Final Equivalent Safety Finding to CS 23.1305, 23.1311, 23.1321 and 23.1549: Powerplant instruments - ELOS-CS23.1305-01

Primary EIS indication on the MFD or on the PFD in reverse mode

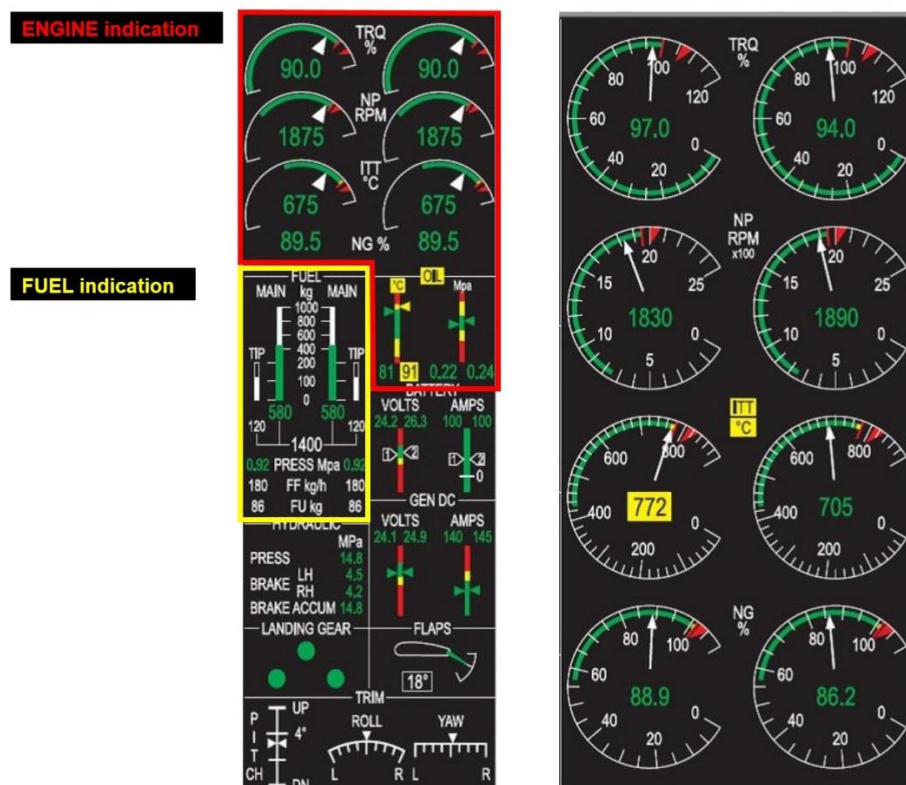
Aircraft Industries must demonstrate compliance with, or demonstrate compensating factors that provide an equivalent level of safety to, the marking requirements of FAR(CS) 23.1549 and FAR(CS) 23.1311. When an applicant proposes a digital-only format for primary display of any rotor speed, or fuel flow parameter required by FAR(CS) 23.1305, EASA will review the visibility, relative location, criticality, and functionality of this display. The design must effectively and safely compensate for any of the explicit or implicit benefits of a traditional analog display. Lastly, Aircraft Industries must show that the availability of the display is commensurate with its criticality. However, since this aspect is not unique to the digital-only format it will not be discussed further here.

Aircraft Industries shall demonstrate that, given the noted shortcomings of a digital-only display format, the proposed digital-only fuel flow displays on the Model L-410NG airplane still meets or provide an equivalent level of safety with all applicable regulations including:

On the primary EIS indicator, where the NG are displayed in only alphanumeric format, the gas generators speed trend can be derived from analog torque indicators and ITT indicators

All the engine parameters primary indications including gas generators speed (NG) and fuel flow indications are displayed on multifunction display (MFD) located on the central instrument panel of the flight deck.

The engine parameters can be also displayed on dedicated window of PFD. The indicators are sufficiently visible to the pilot and co-pilot. Any negative effect of vibrations was not observed.

On secondary page of EIS, which can be displayed on either MFD or PFD, the NG together with all other engine parameters are displayed in the way of conventional gage with scale and pointer accompanied with alphanumeric presentation.

located on EIS just above the NG indications since both torque and ITT are related to gas generator speed. For ground engine starting and in flight starting the use of secondary EIS page with full information about engine parameters is recommended in AFM.

There is a color change of alphanumeric indication when gas generator approaches to its limiting values. There is a caution range in which the alphanumeric indication is provided by yellow color and over-speed range in which the alphanumeric indication is done by red color. Furthermore in case of the gas generator speed limit overrun the CAS notification is displayed on the MFD similarly as in case of other engine parameters exceeding.
